North Tower Response to OSD and Metro DRP Feedback

DRP 7 North Tower

SMMP—ISD

18 December 2018

Feathered steps and detailing

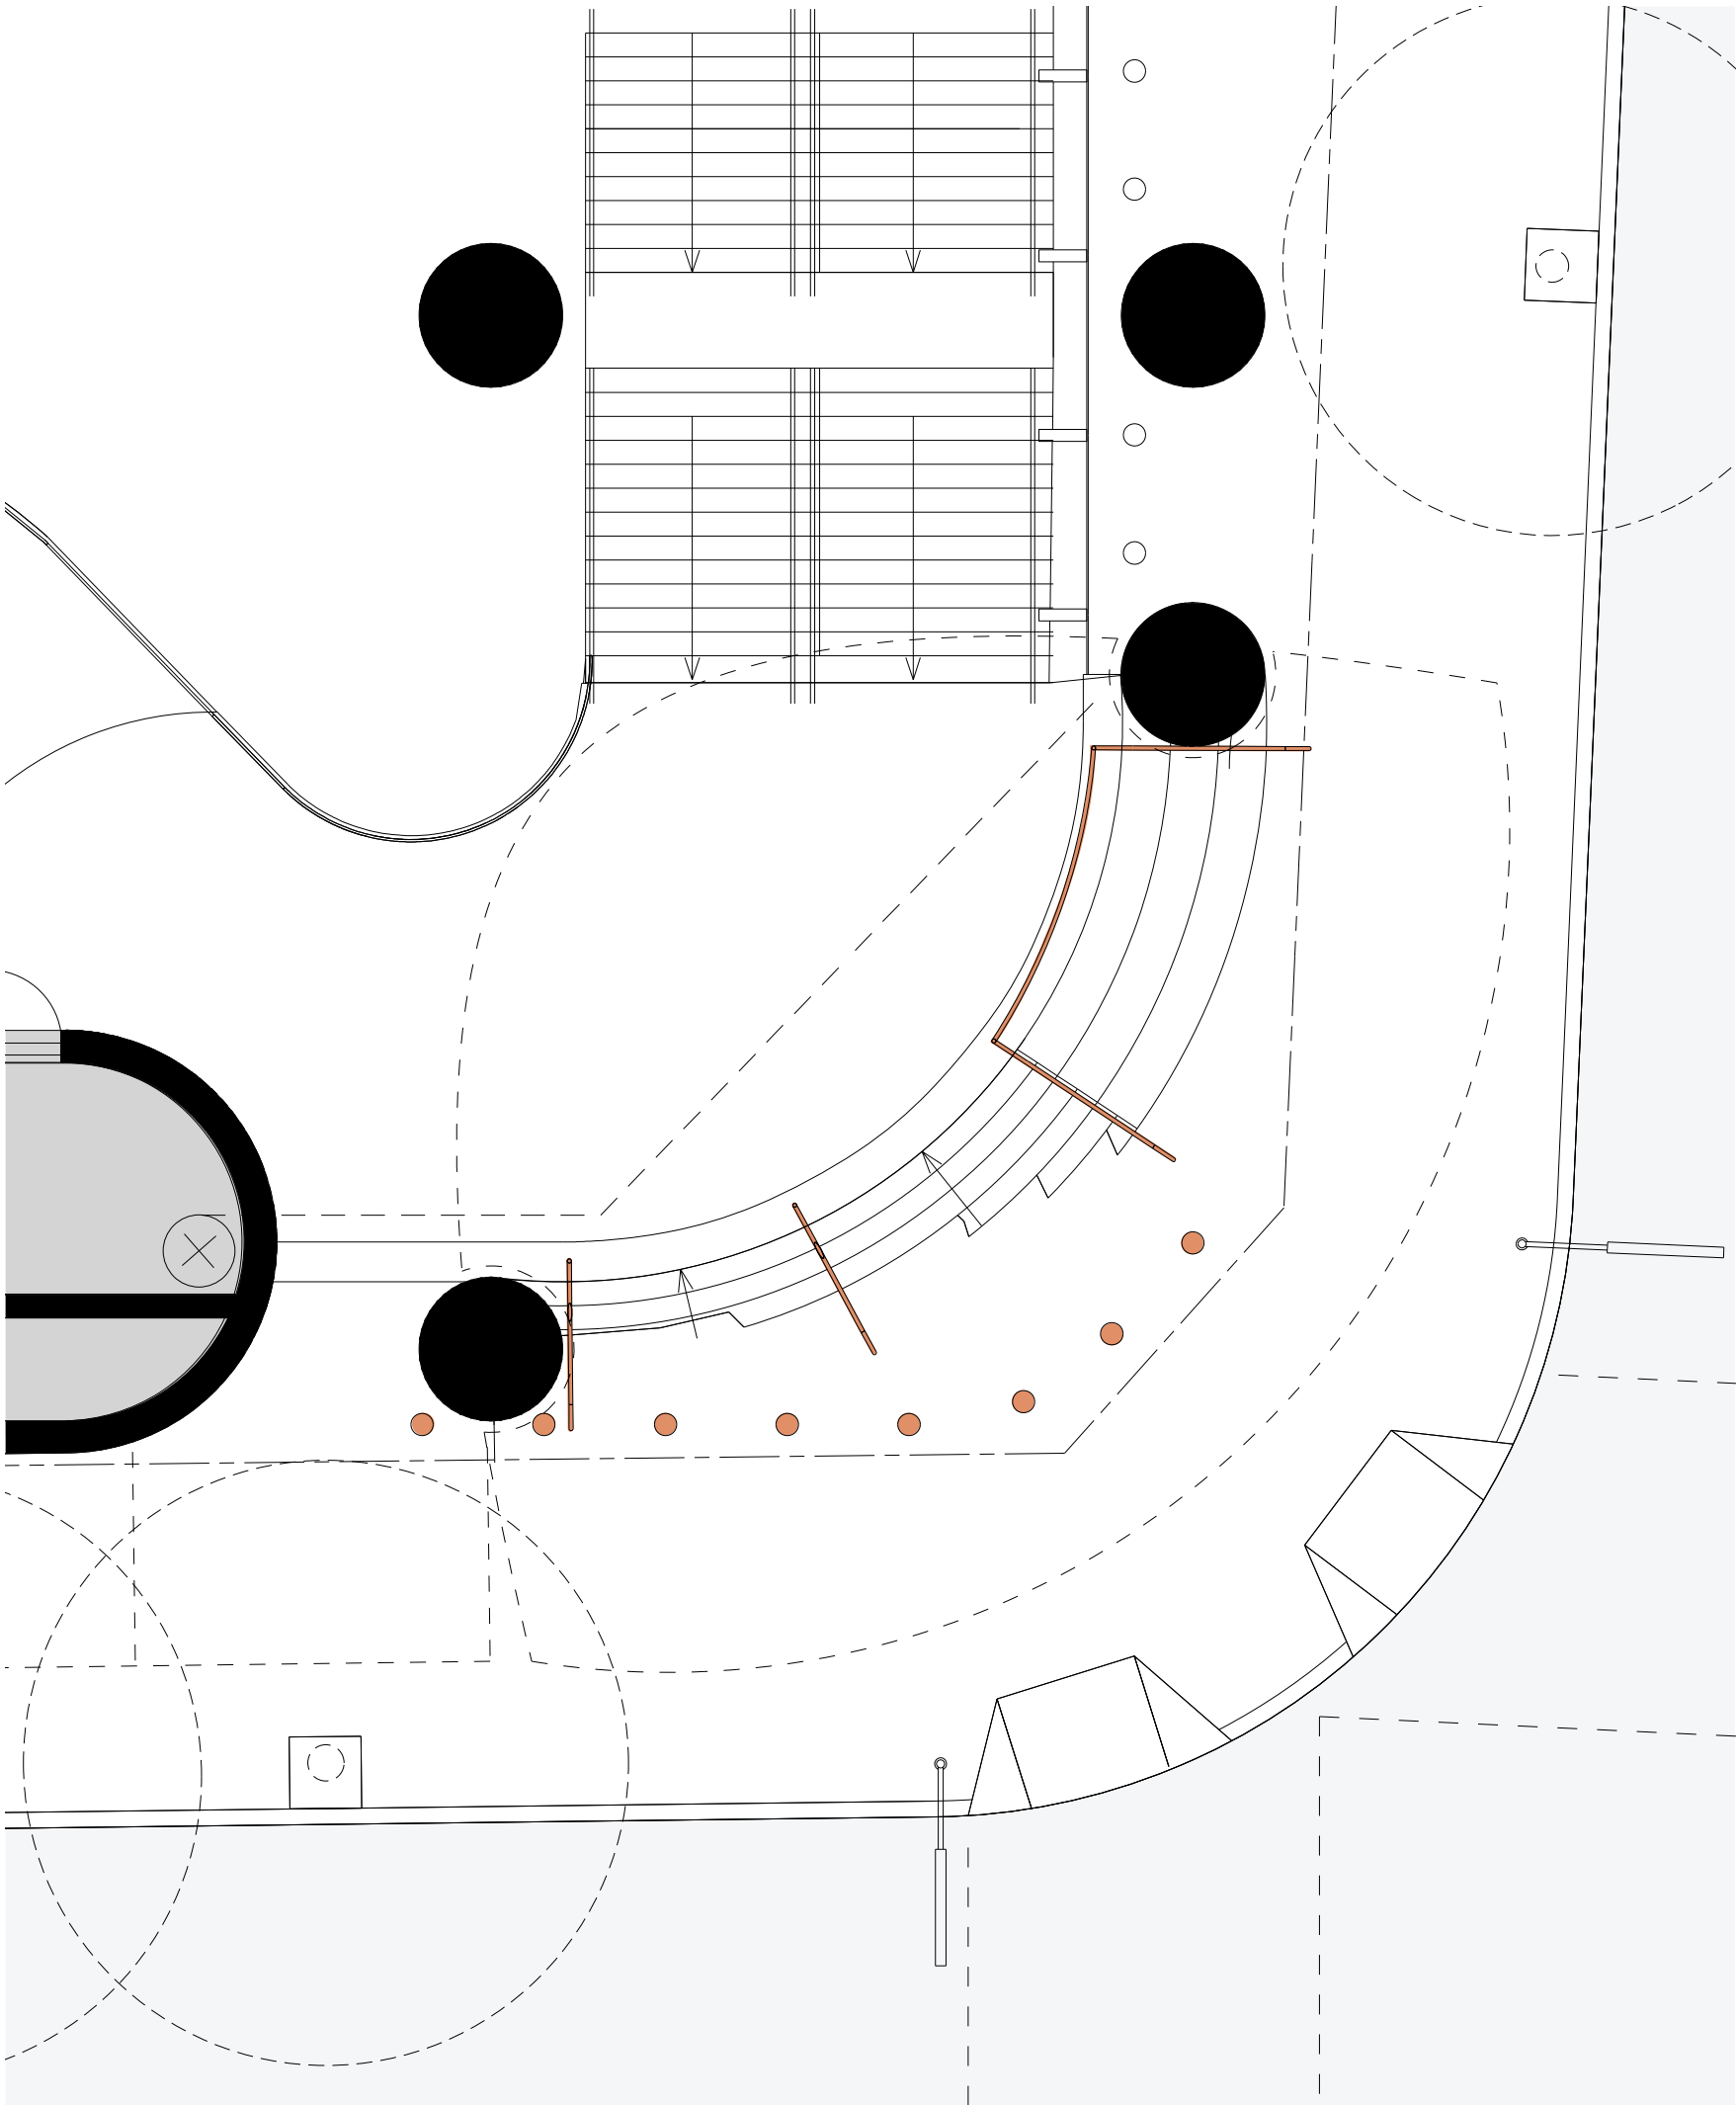
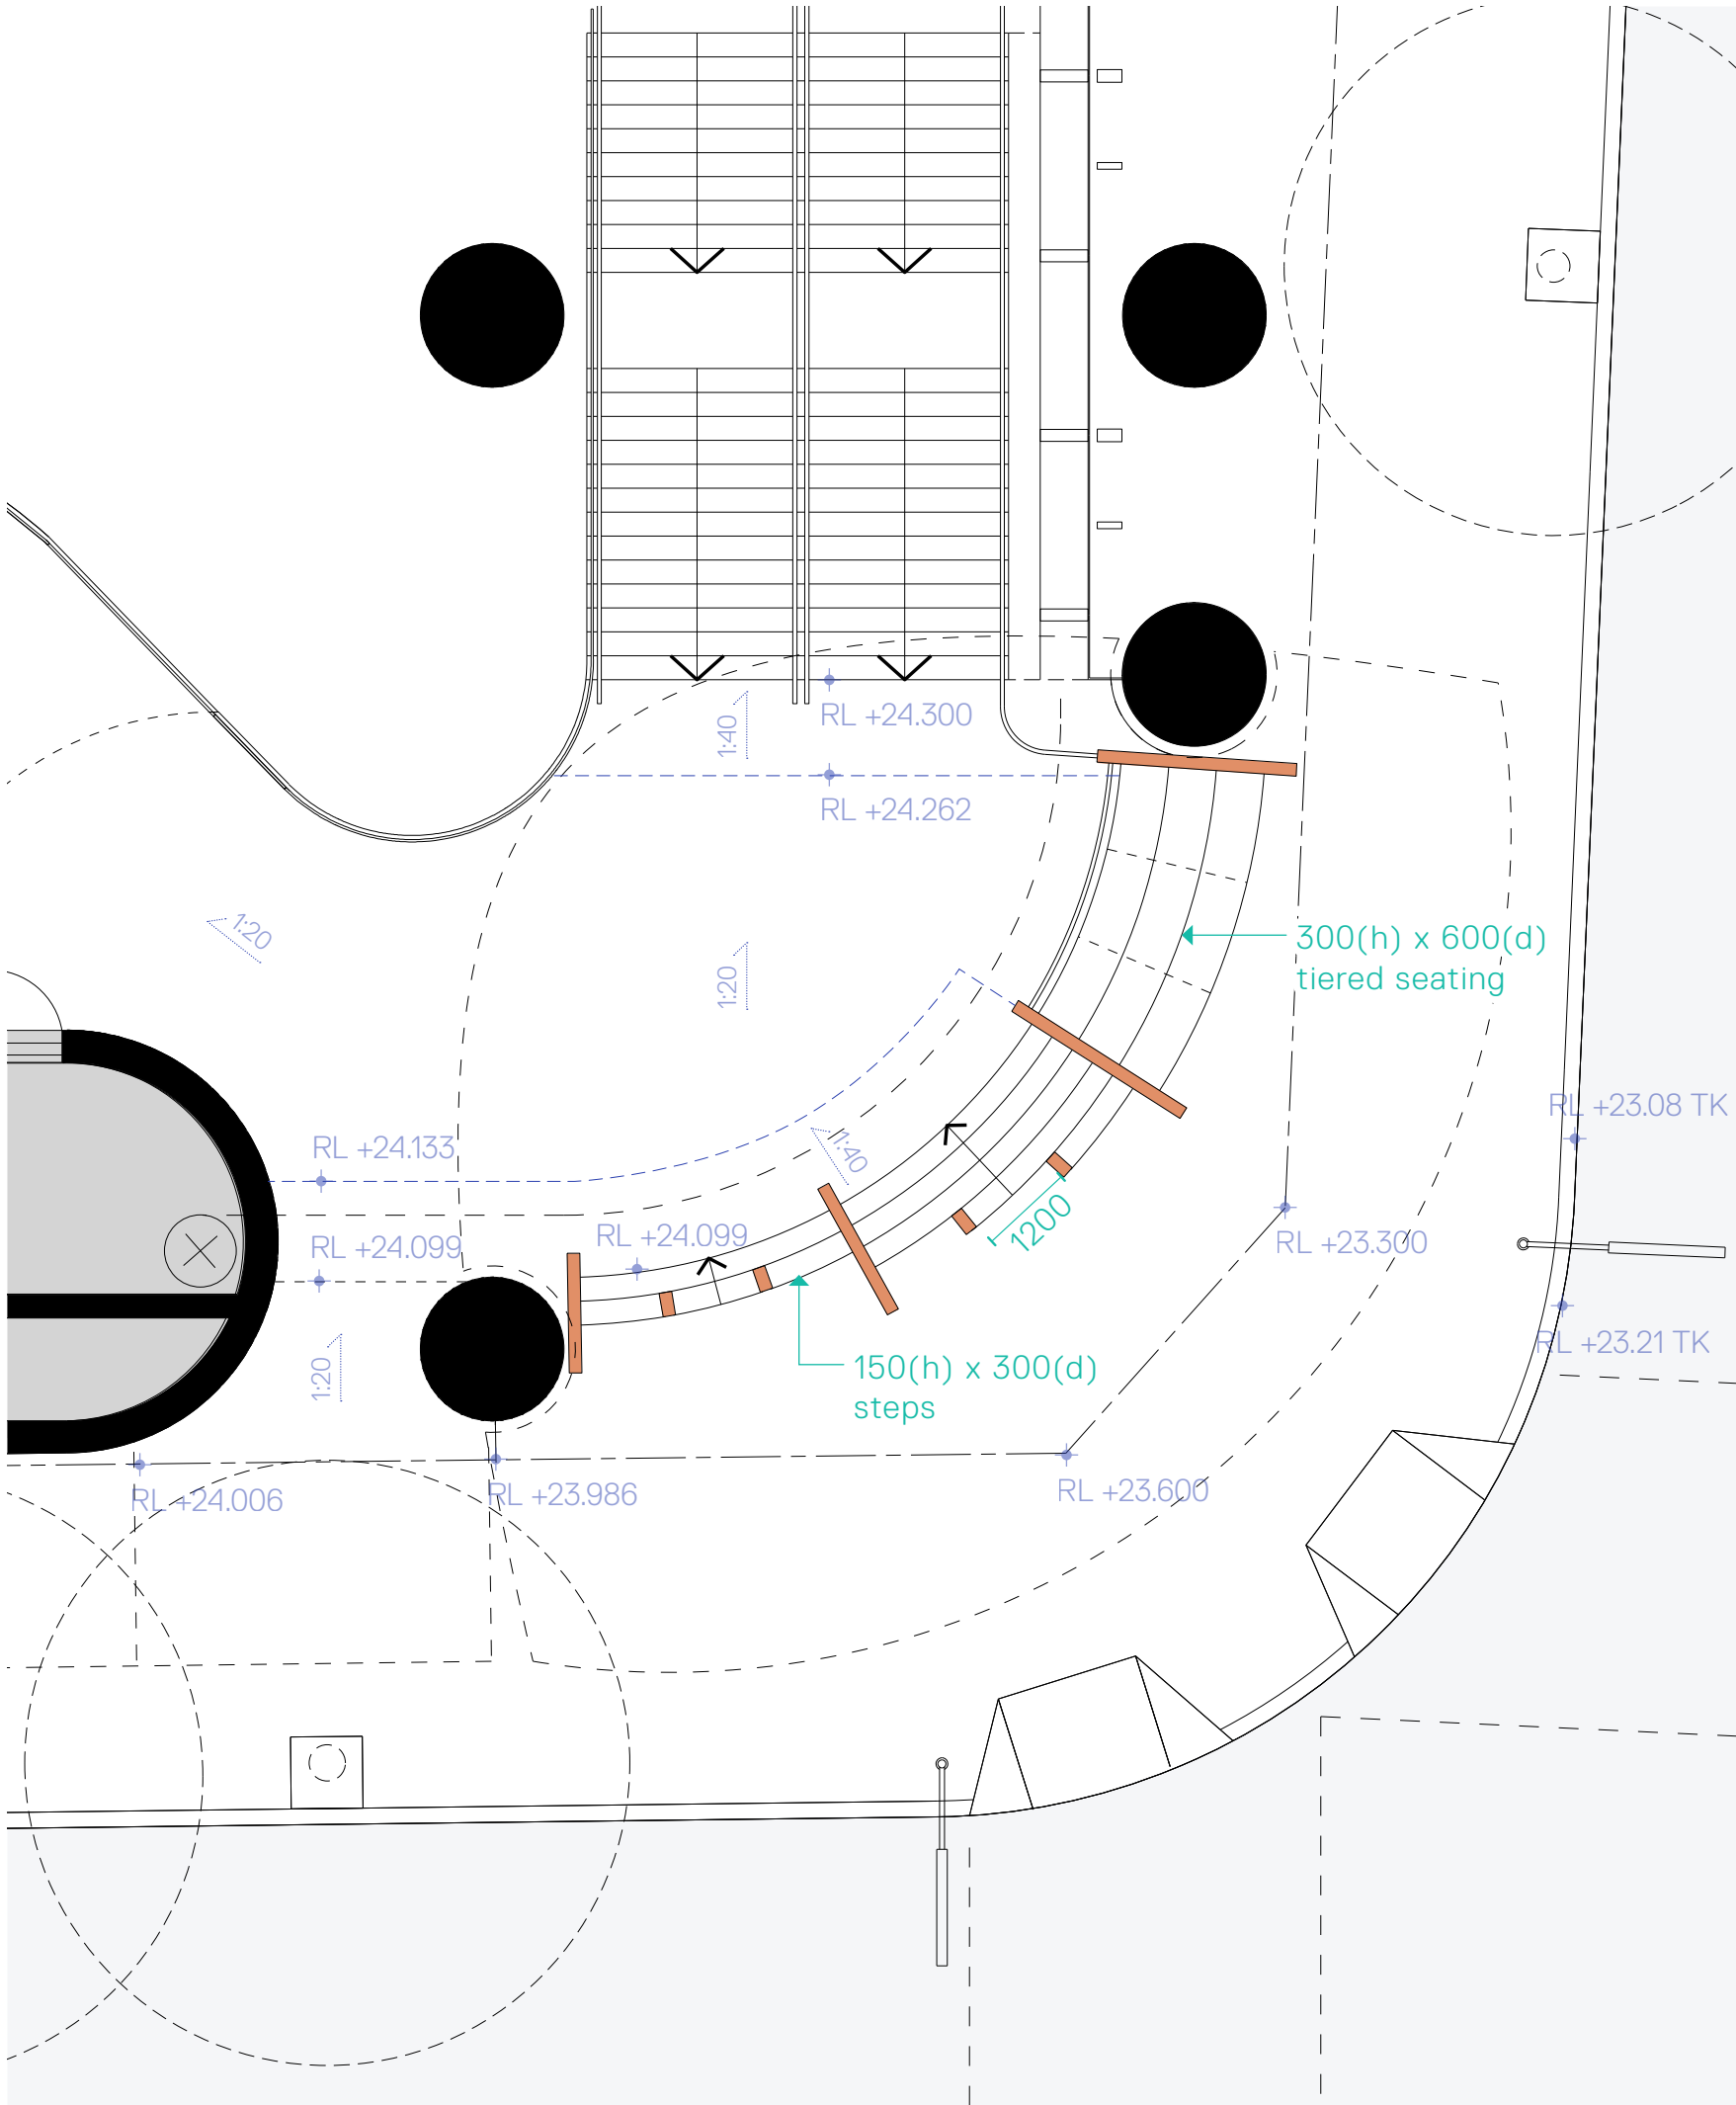
OSD DRP comment:

“Further design refinement is required to address **how the seating steps meet the column** on the northern elevation.”

Station DRP comment:

“The building’s interface with Hunter Street still requires improvement, particularly to **avoid the sections of feathered steps**.”

“Further design development to **avoid feathered steps** at the Elizabeth Street entry and to provide the appropriate civic response along Hunter Street.”

Proposed

Note: RLs shown in proposal reflect the current DA scheme, based on a 2.5% cross-fall from top of kerbs. Subject to detailed development and below-ground utilities survey information currently being undertaken.
